ADDENDUM NO. 02

July 25, 2025

Clark-Pleasant WCHS Phase 3
300 E Main St.
Whiteland, IN 46184

This Addendum consists of Pages ADD 2-1 through ADD 2-3 and attached Lancer Associates of Architects, Addendum No. 02, dated July 23, 2025, consisting of 8 pages, Specification Sections 08 41 15 and 28 23 00, and Addendum 2 Drawings: Drawing :208, 300, 500, 801, L101, L201, S002, S101G.2, S101GR, S101N.1, S101N.2, S102A, S102N.2, AD101G, A101GR, A141, A315, A316, A318, A731, A750, A760, PD100G.2, P100G.2, P101G.2, E702, E703.

1
S102N.2
SECOND FLOOR AND LOW ROOF FRAMING PLAN - UNIT N.2
SCALE: 1/8" = 1'-0"

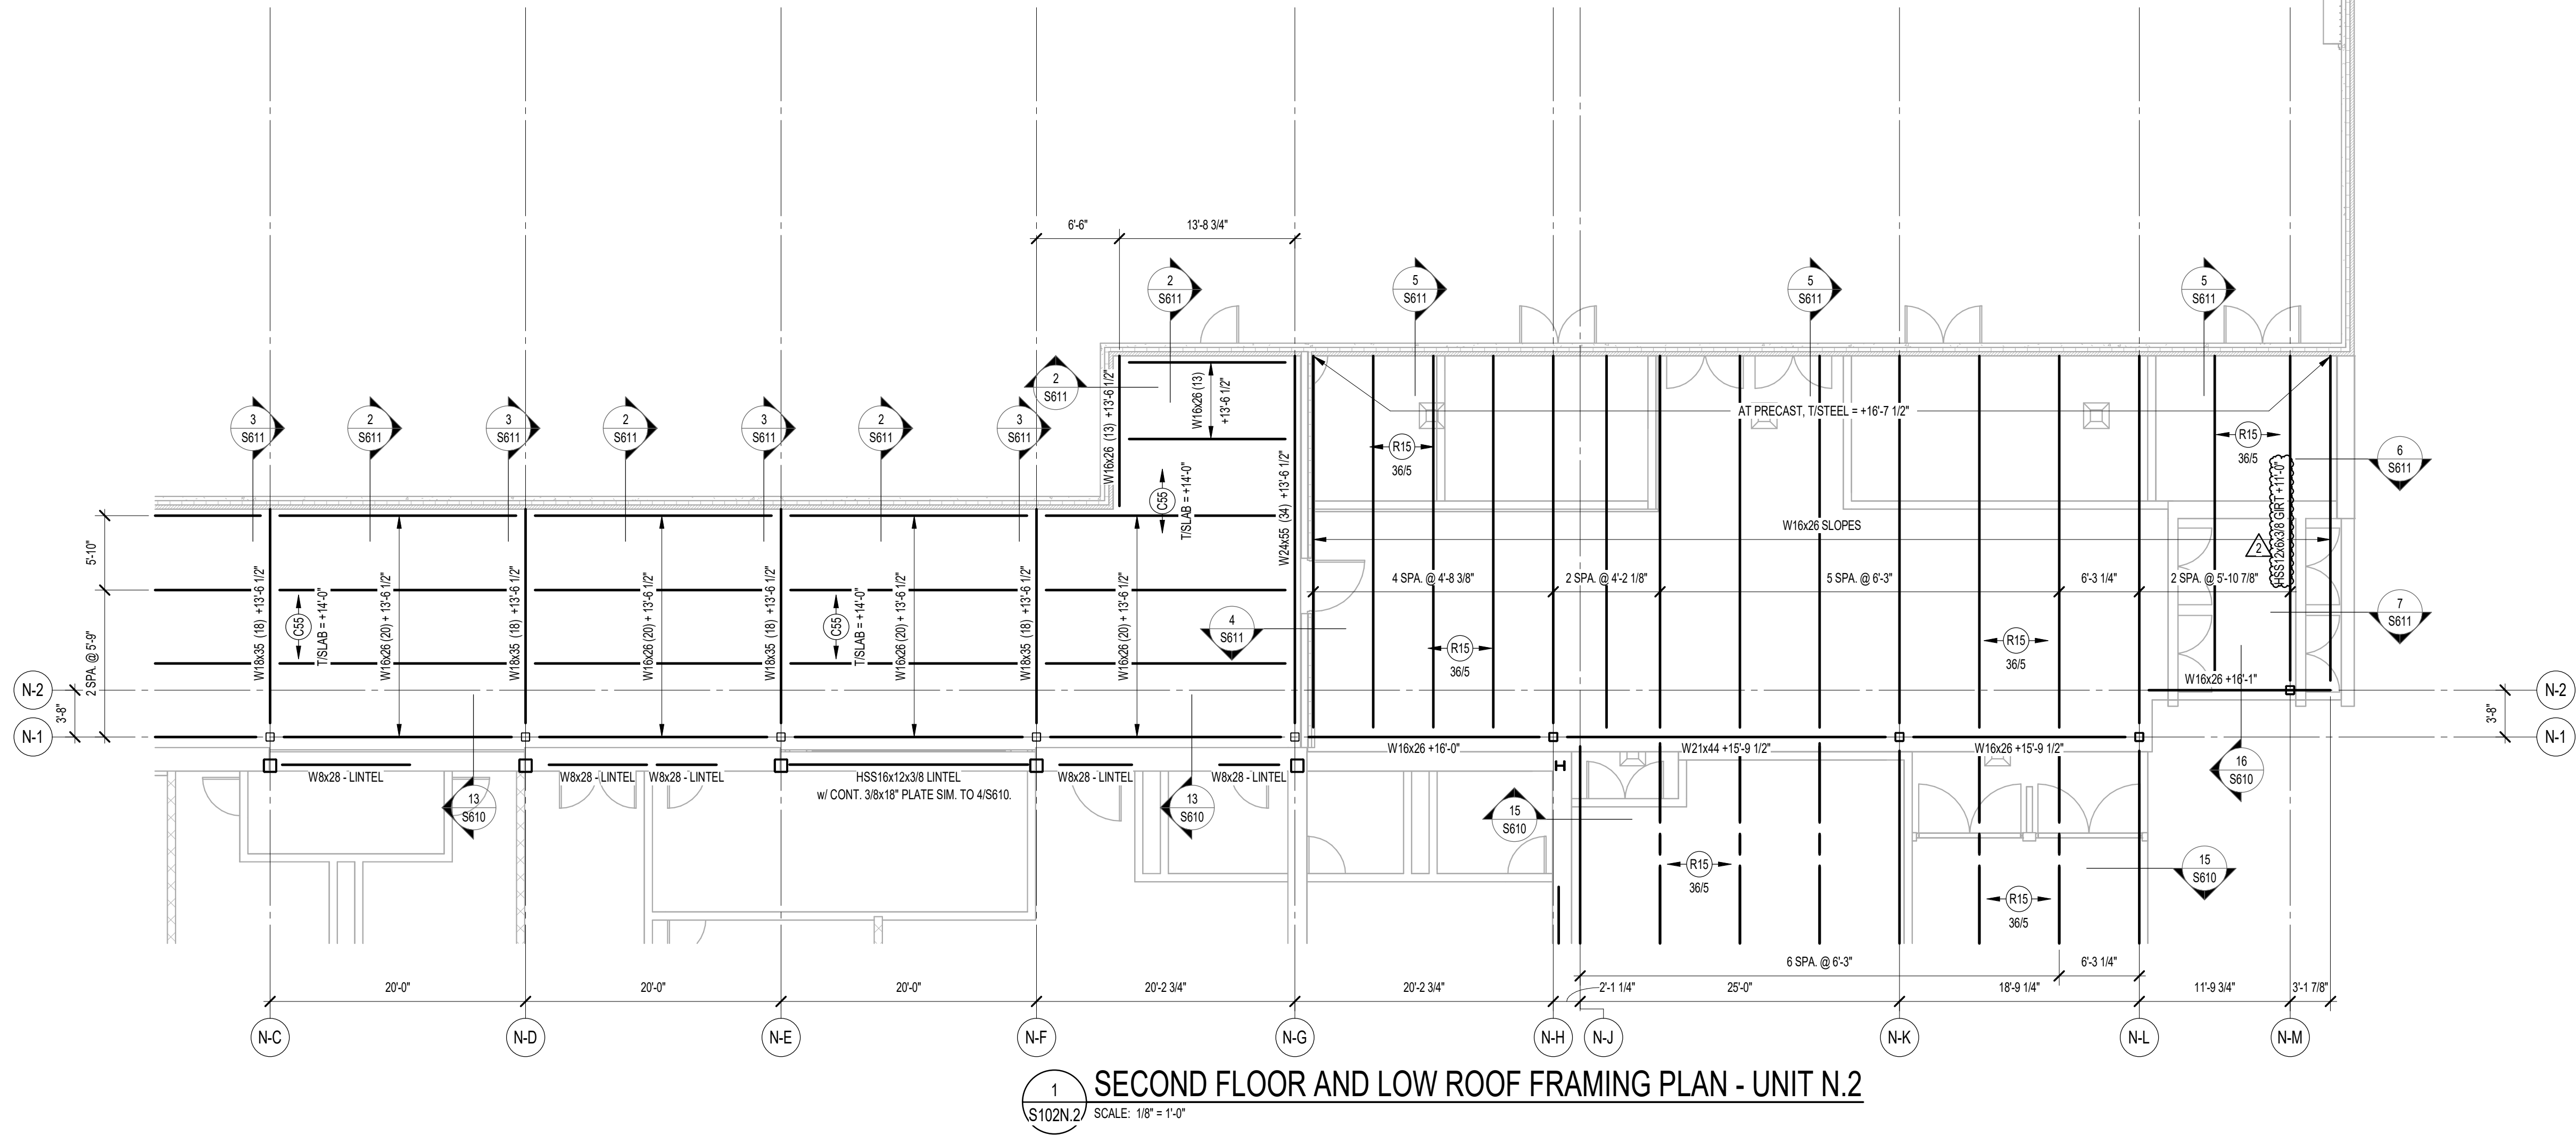
- a. New sheet showing added joist reinforcing details and requirements for new piping in existing building.
7. Drawing S102N.2 – SECOND FLOOR AND LOW ROOF FRAMING PLAN – UNIT N.2

- a. Provided steel girt sizing.
8. Drawing: A141 Roof Plan
Change:
Changed keynote 8 to read: “REMOVE EXISTING ROOFING AND GRAVEL BALLAST, REUSE EXISTING INSULATION. RE-ROOF THE EXISTING ROOF, RE-USE EXISTING ROOF EDGE COPING AND EDGES”
Added keynote 10 to the roof to the south-east
See attached

AD101G

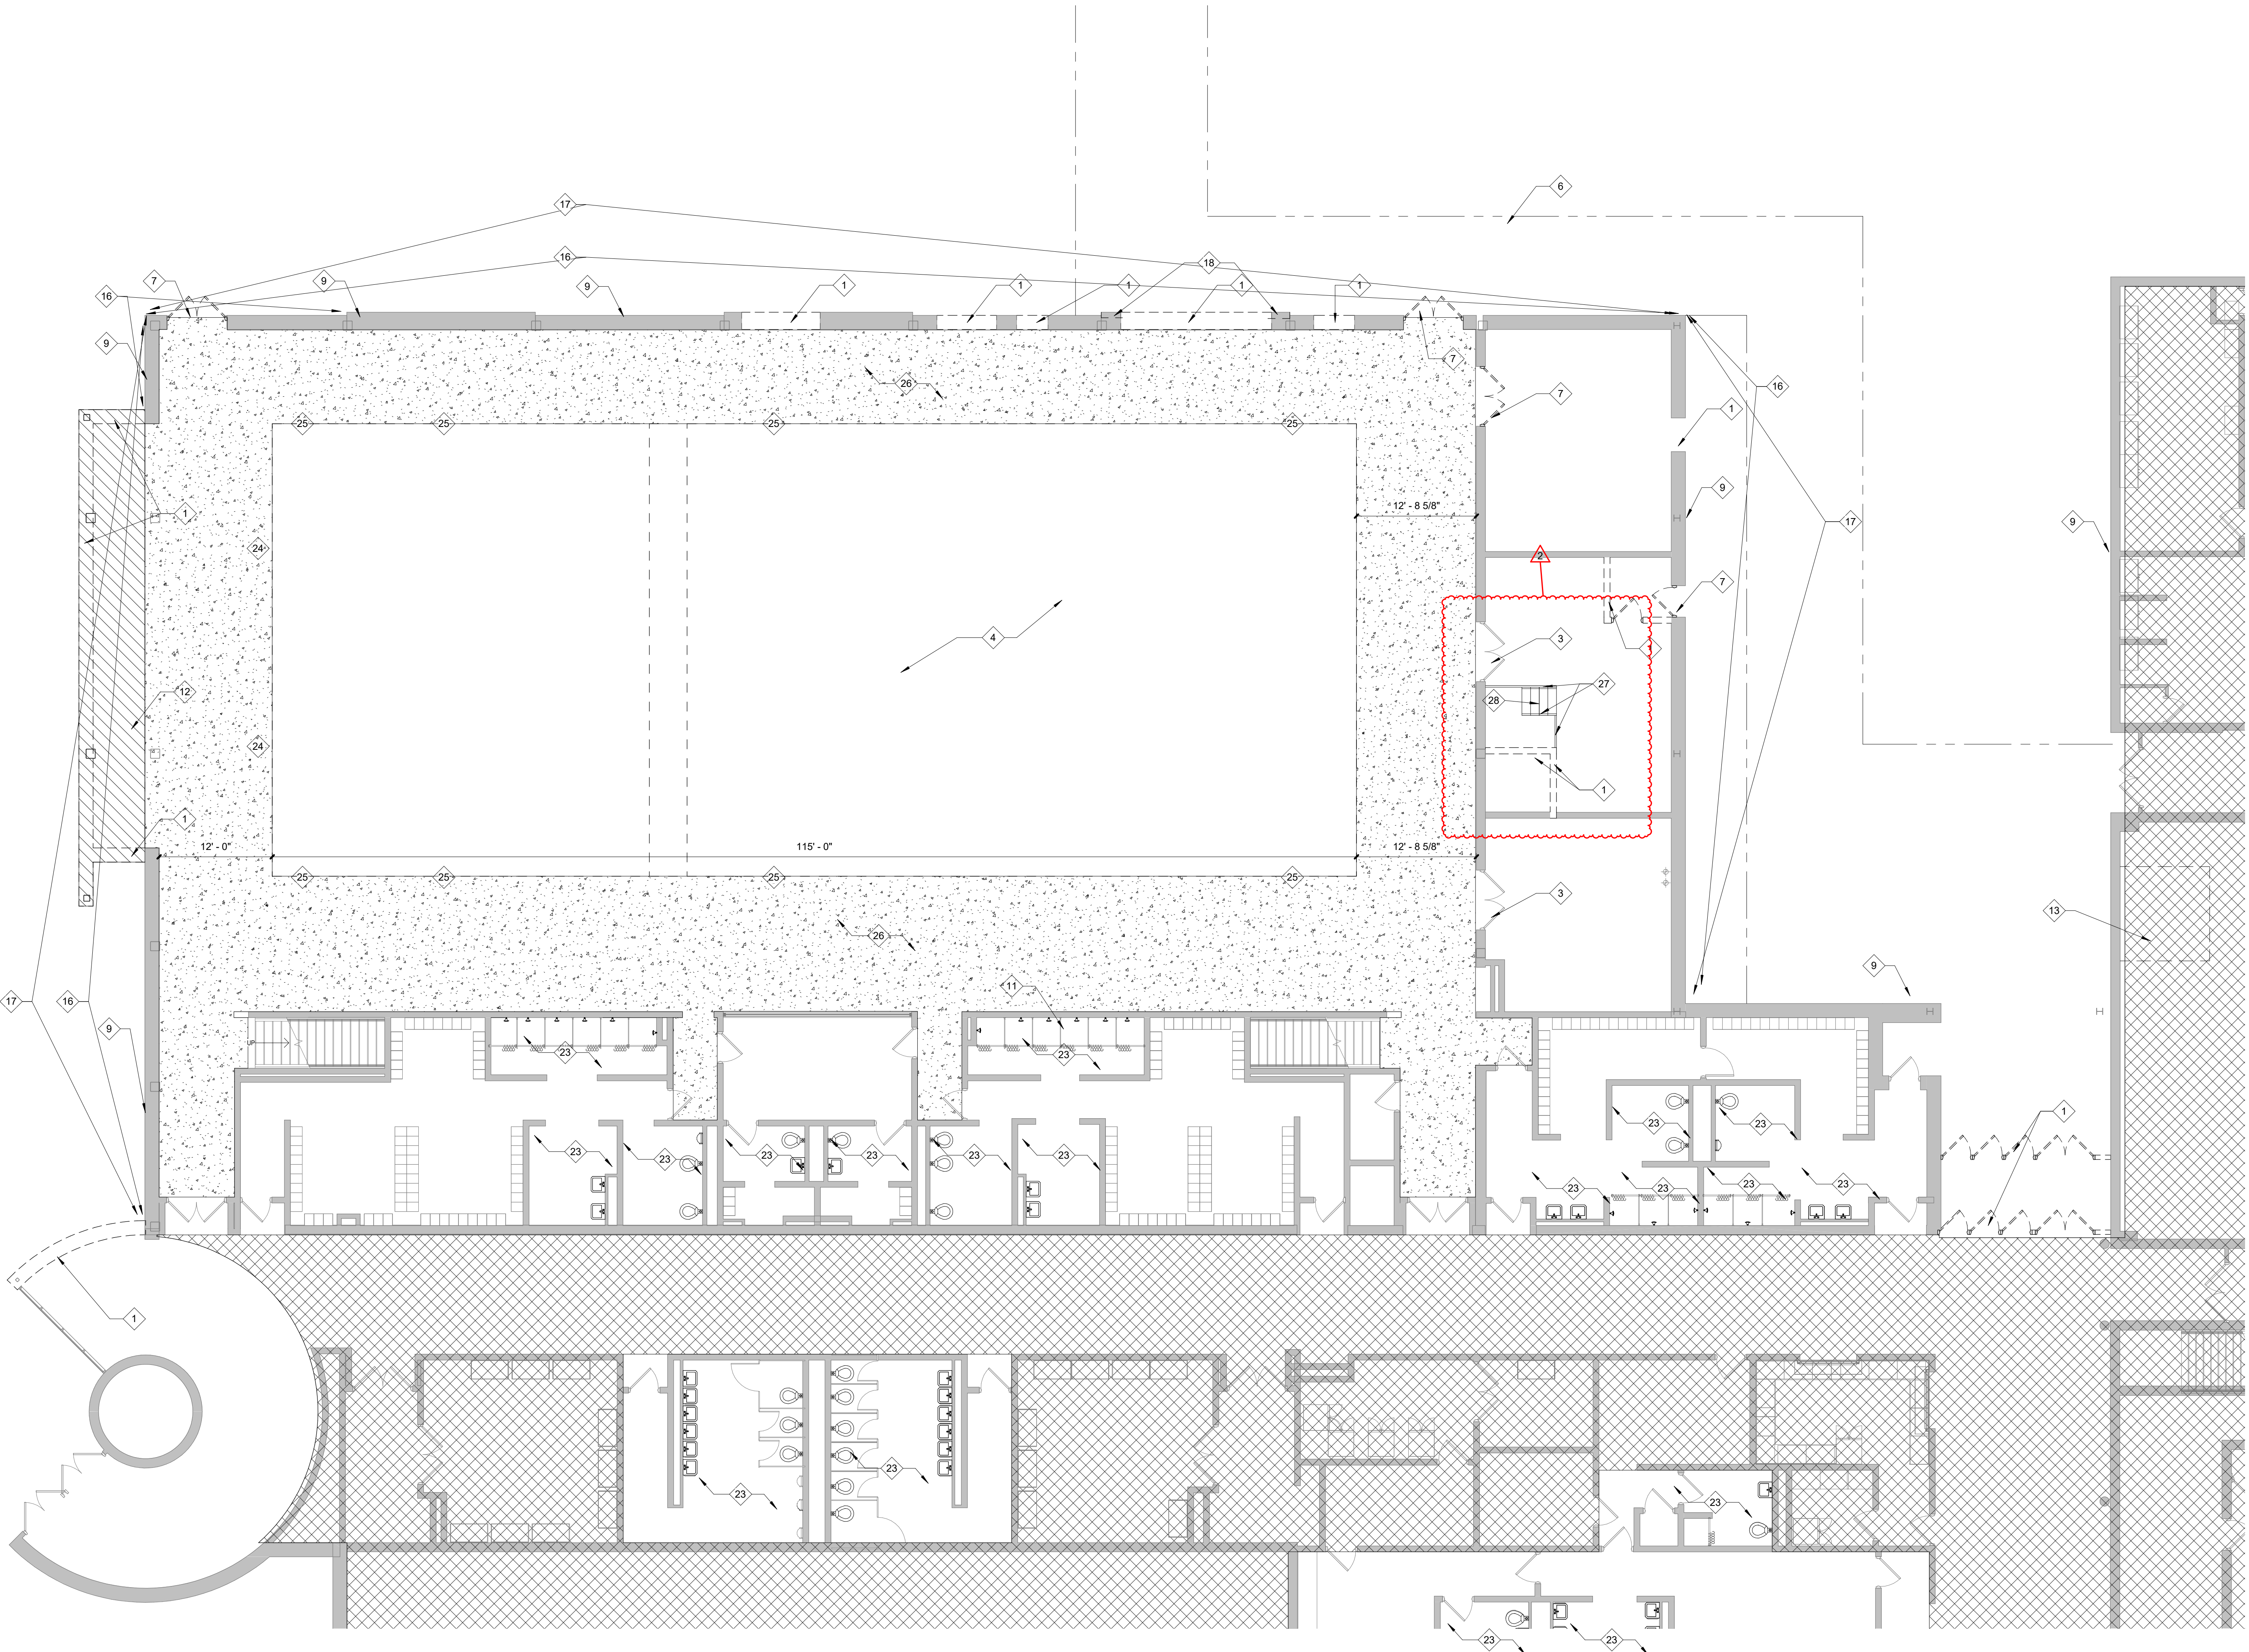
Q: On the demo drawings it indicates to remove the pool tile (plan note 4 on AD 101G). with the pool shell being abandoned in place, is it acceptable to leave the pool shell tile in place below grade as the pool walls and floor are being left in place.

Q: On demo drawing AD101G note 26 it indicates to Demo Deck, Patch Finishes as needed for new work. This note appears to be contradictory. We are assuming that "Demo Deck" means to demo the deck tile but the patching of finishes is throwing us off as that appears to mean the tile remains and is to be patched. Please clarify the intent of this note.

9. Drawing: AD101G DEMOLITION PLAN - FIRST FLOOR - UNIT G
Change:
Added clarification drawings of location of existing stairs and railings in the pool mechanical room.
Change keynote 7 to read “DEMO EXISTING DOOR AND FRAME. CLEAN, PATCH AND PREP SURFACES FOR NEW WORK”

A141

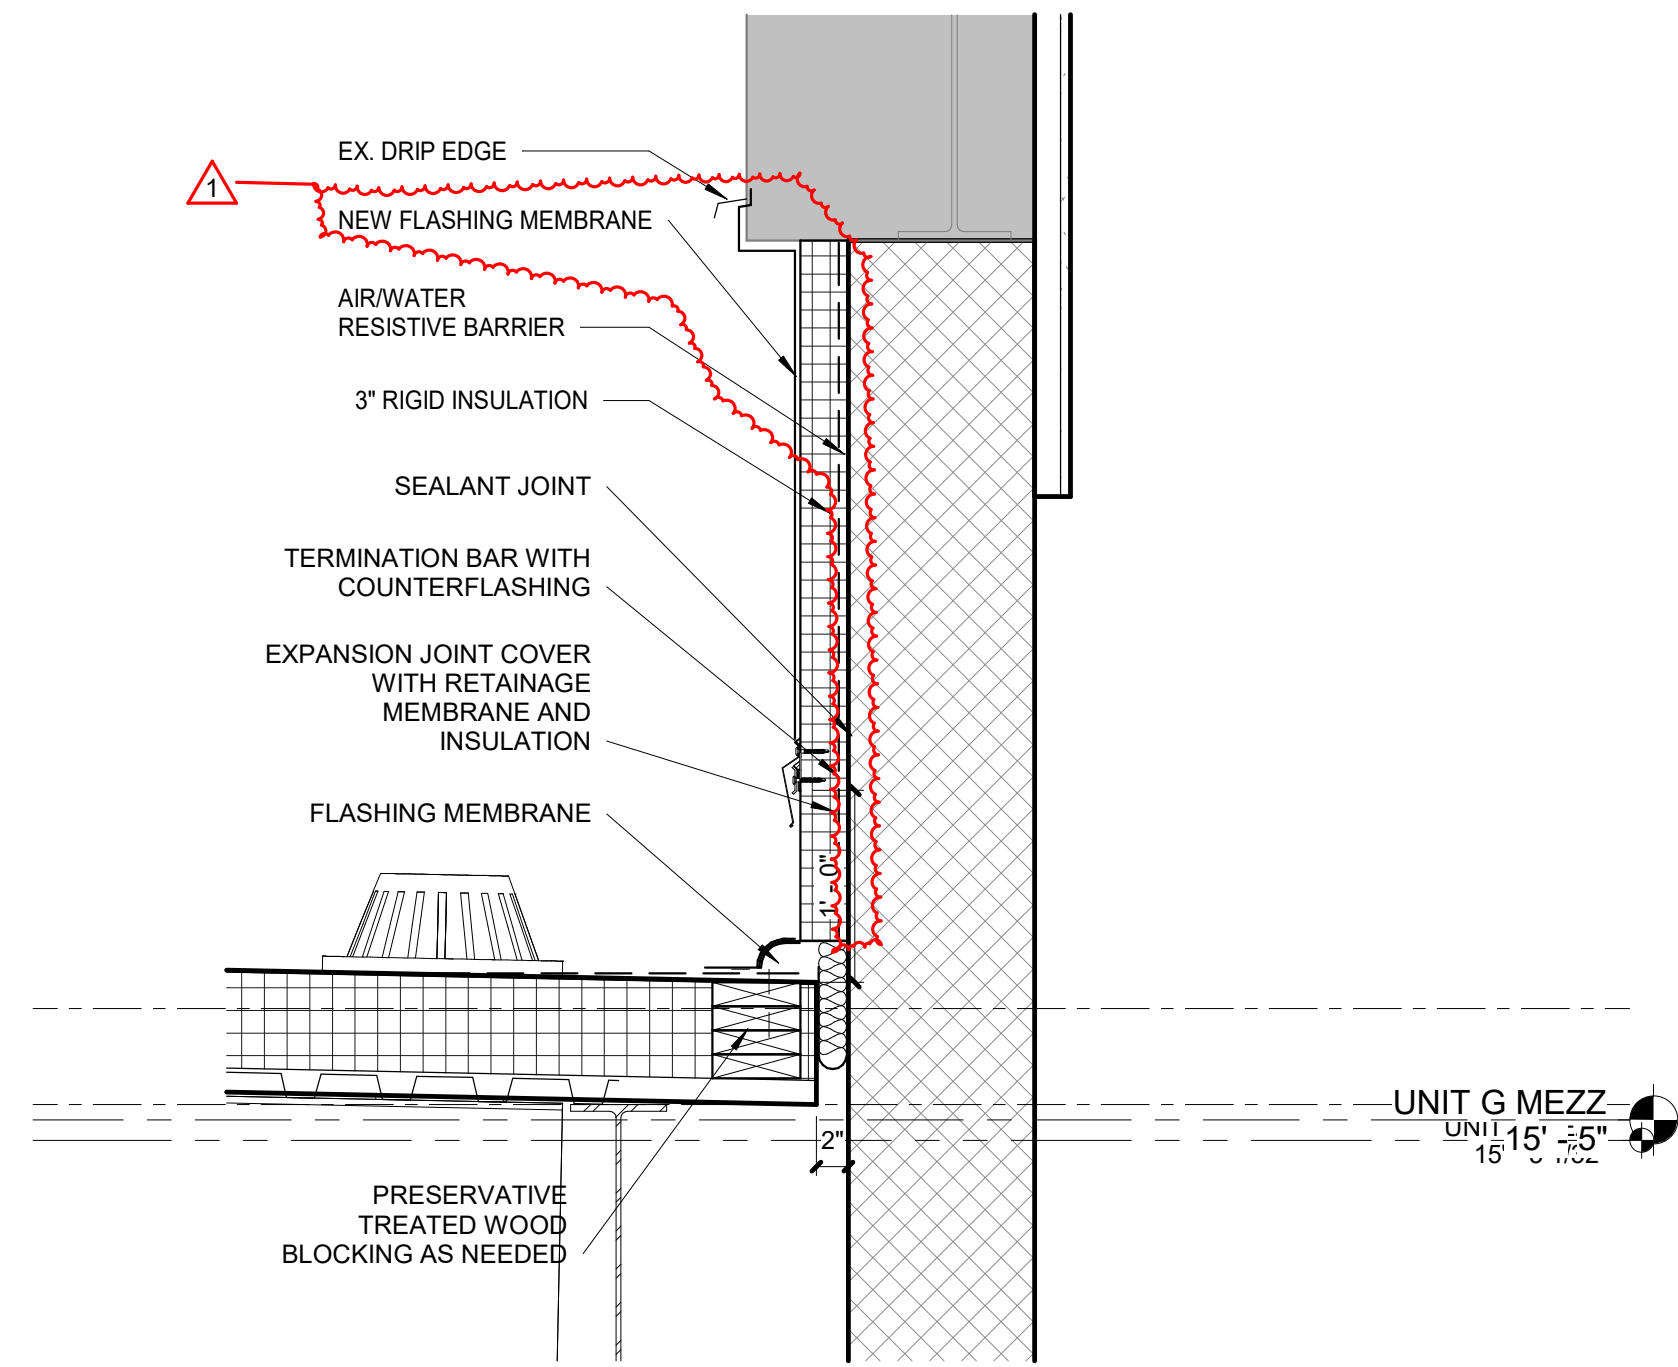
Q: Sheet AD141 - Note 15 says to remove the ballast and roof membrane. On sheet A141 note 8 says to re-roof existing building after roof deck reinforcement. Is the intent to remove the membrane only and re-use the existing insulation or is the intent to replace all of the roof components to the deck? Can the designer please issue a roof assembly type for this roof area on an updated sheet A003?

A: The intent is to remove the membrane only and re-use insulation. The existing roof is gravel ballast over membrane roof over 4" min insulation of 5/8" type x gypsum board base over metal deck
